**SINSW - JPPS
RESPONSE TO SUBMISSION PROGRAM AND TASKS**

Thank you for your email dated 22 November 2021, requesting the review and preparation of written responses to address concerns raised pertaining to the **SSD-23330227 - Upgrades to John Palmer Public School**.

Project
John Palmer Public School

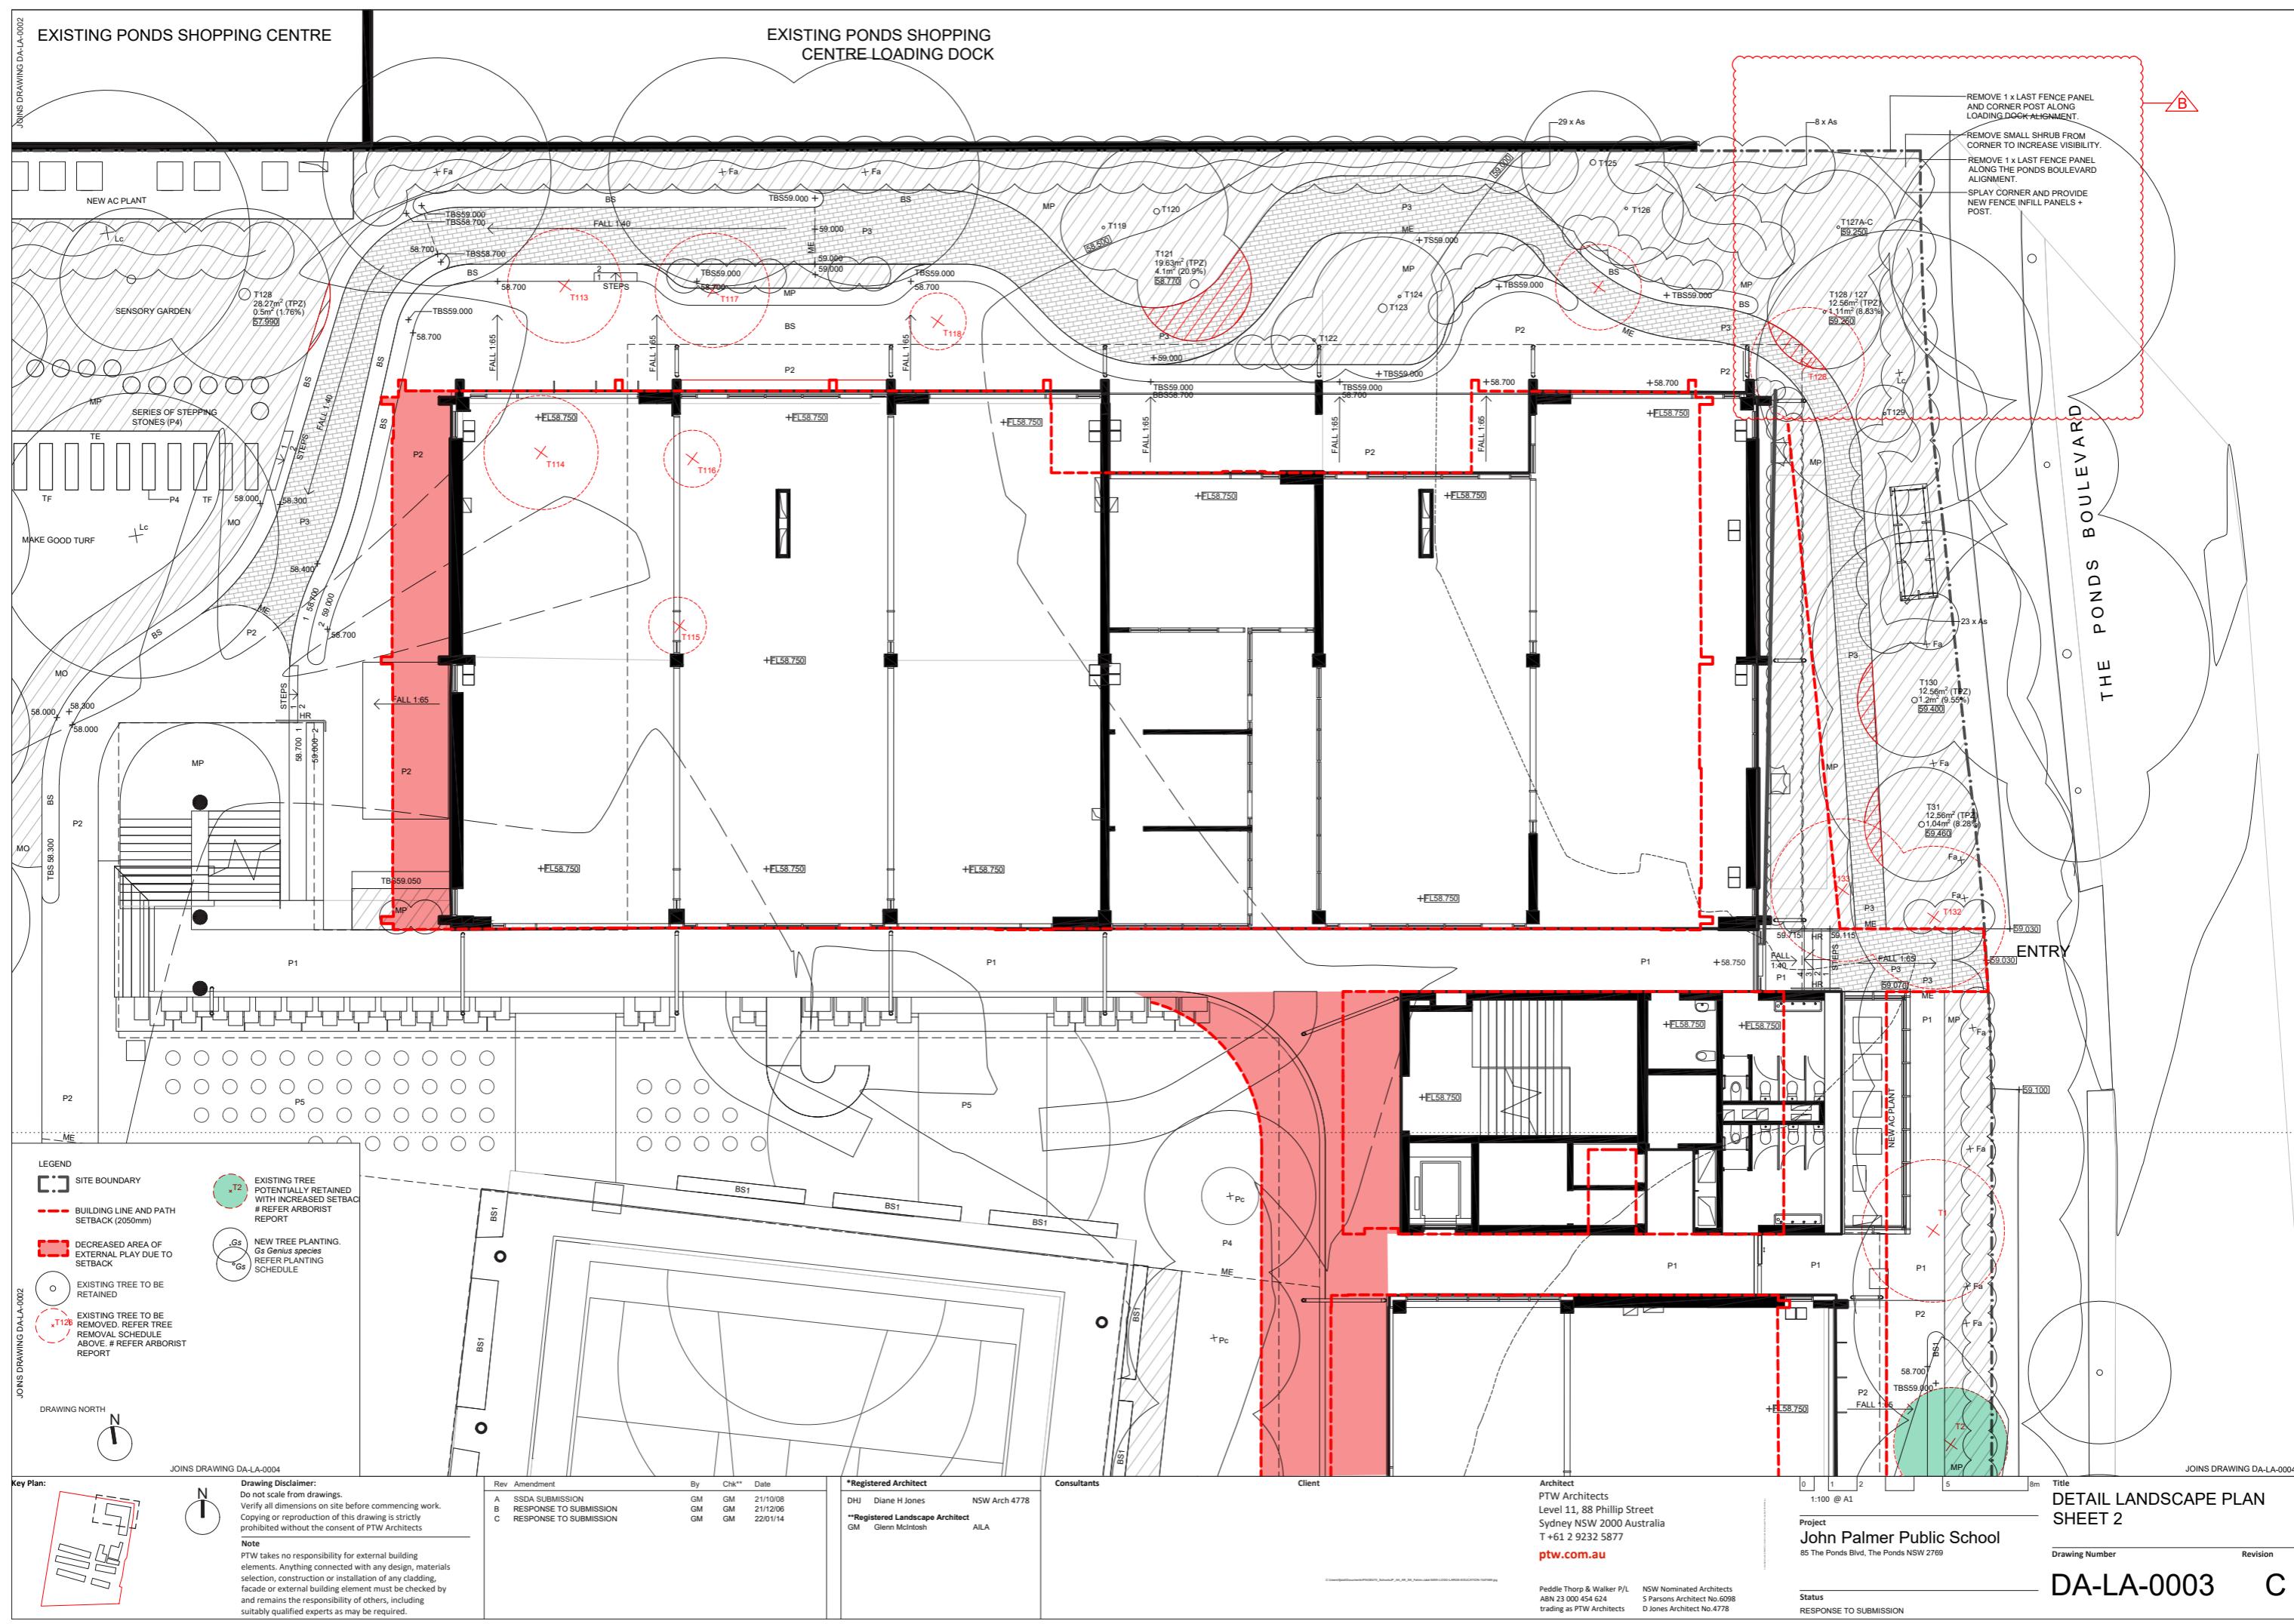
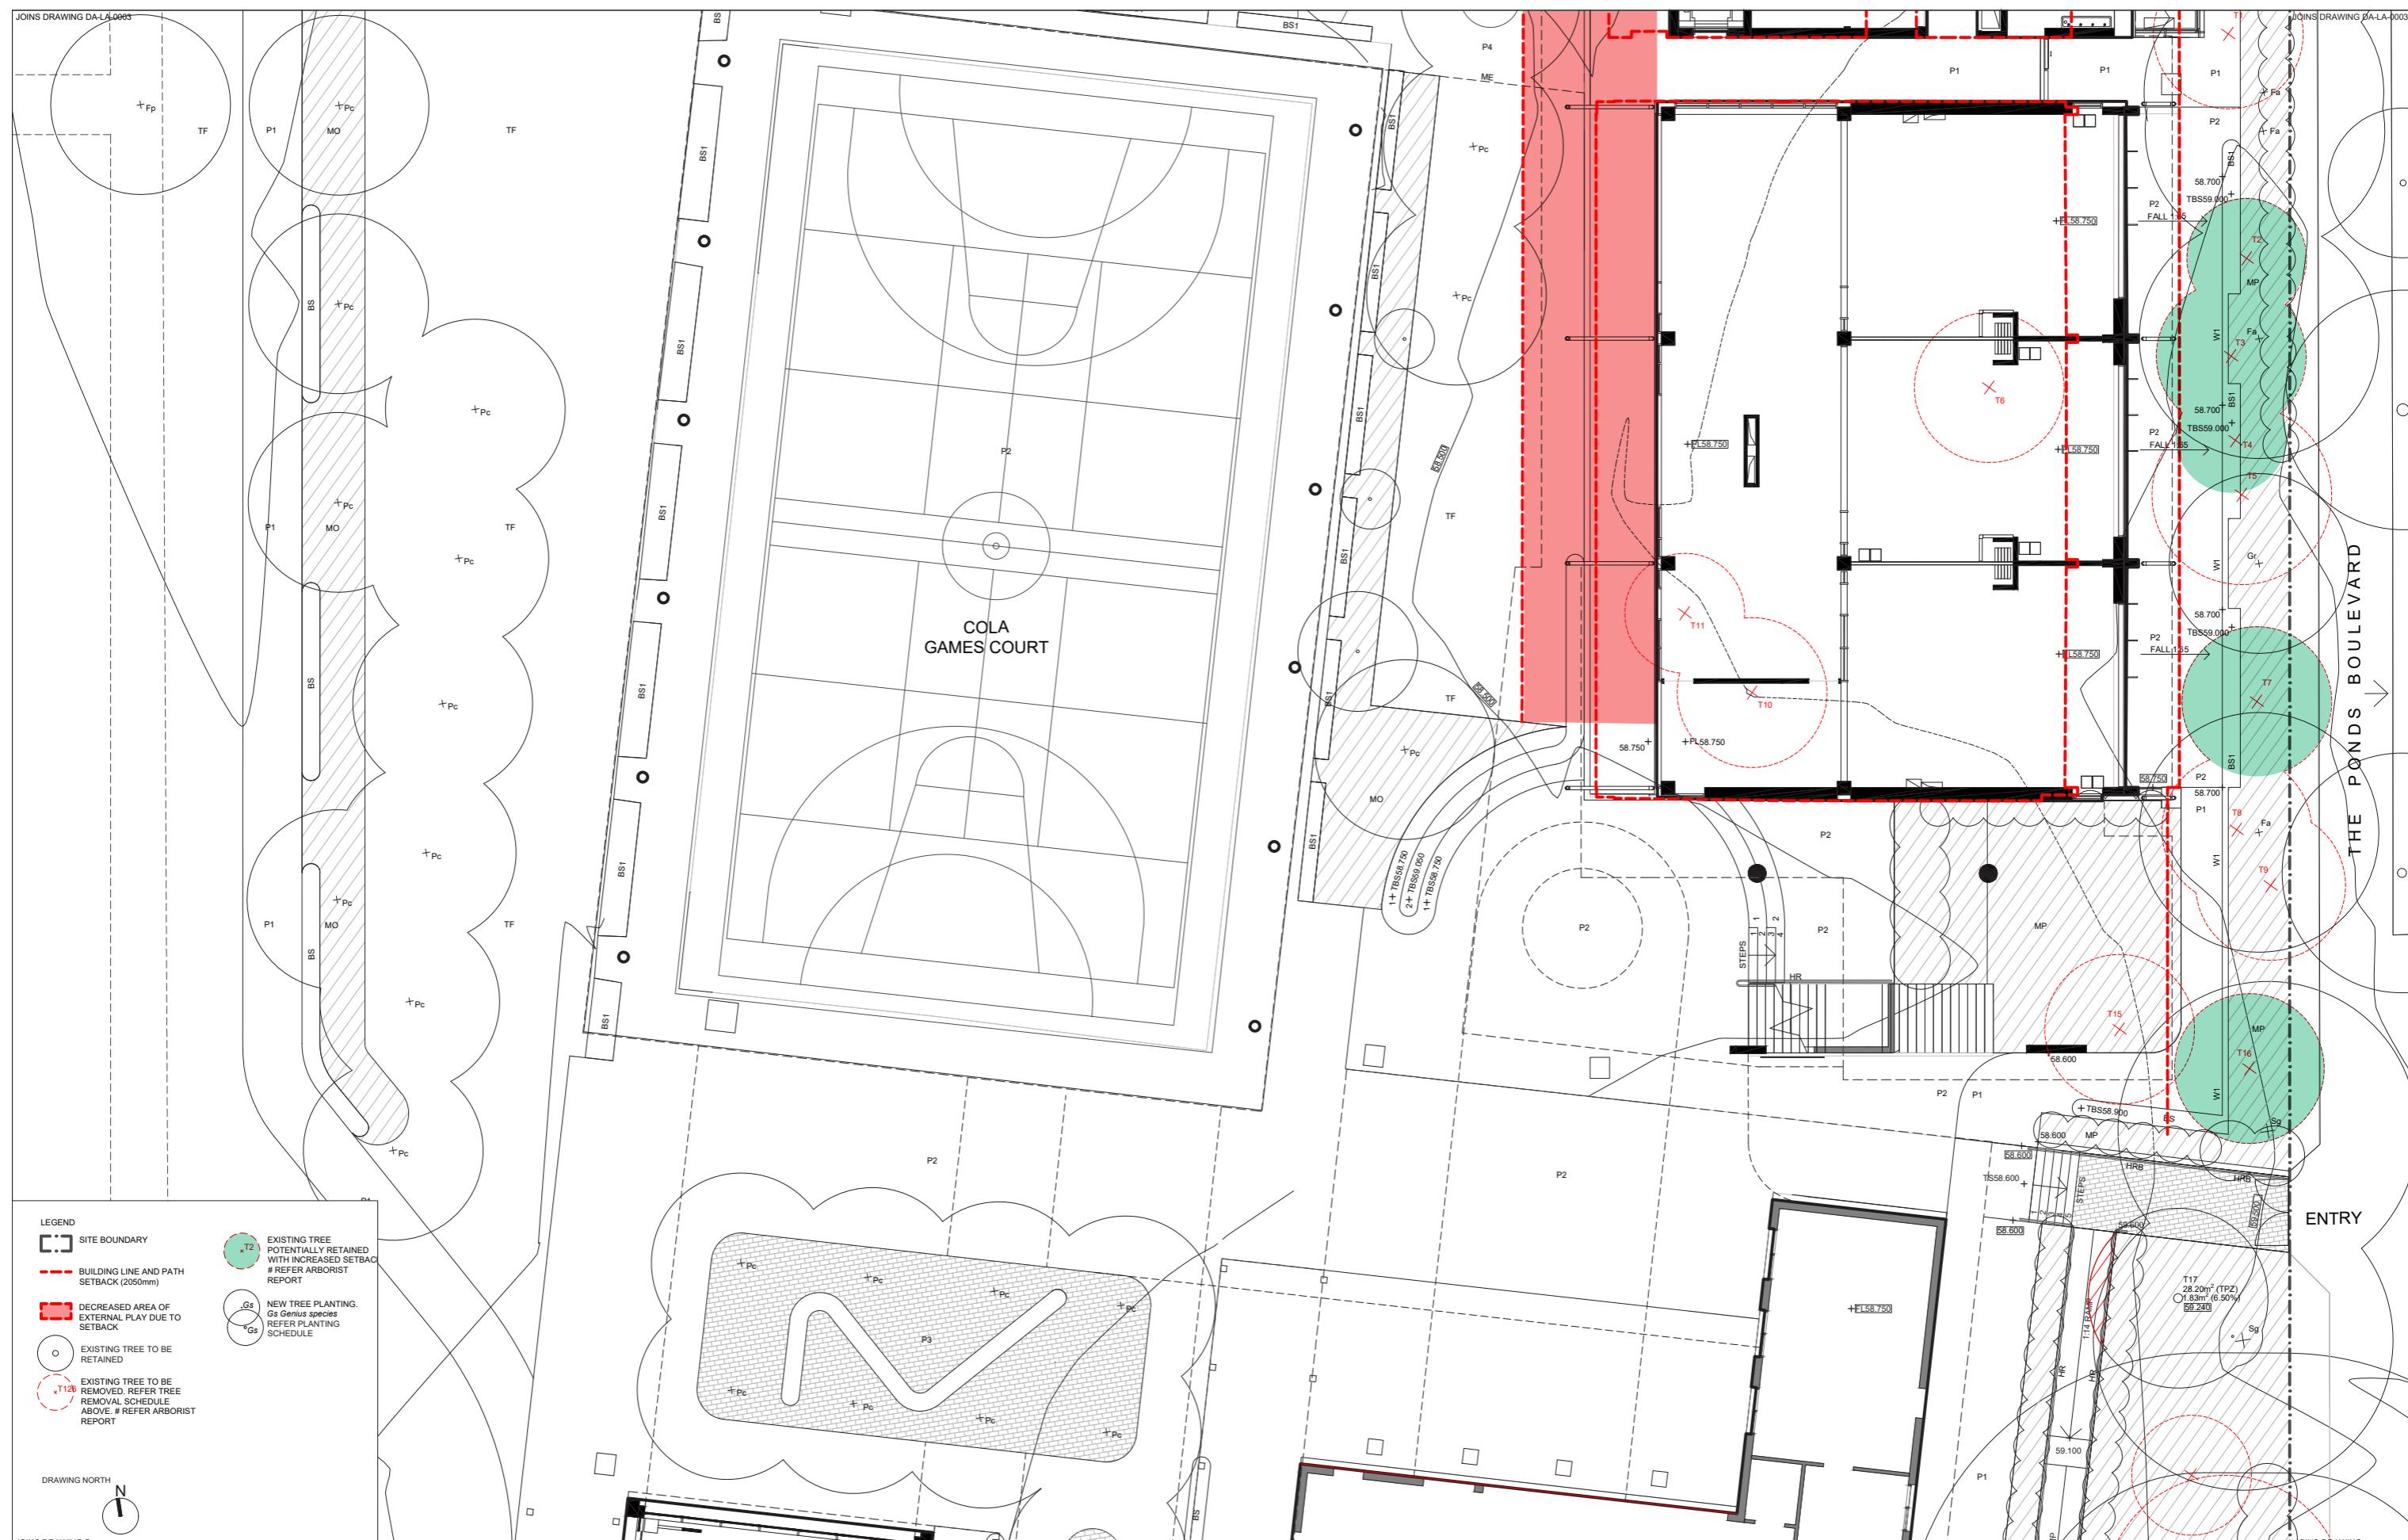
Screening vegetation around a padmount substation should be planted a minimum distance of 800mm plus half of the mature canopy width from the substation easement and have shallow / non-invasive roots. This is to avoid trees growing over the easement as falling branches may damage the cubicle and the electricity infrastructure as do tree roots. All vegetation is to be maintained in such a manner that it will allow unrestricted access by electrical workers to the substation easement all times.

McIntosh & Phelps has modified the location of screen planting species located around the padmount in accordance with the recommendations by Endeavour Energy; “a minimum distance of 800mm + 1/2 of the mature canopy width from the substation easement, and have shallow / non - invasive root systems” (Refer DA-LA-005 Rev. B).
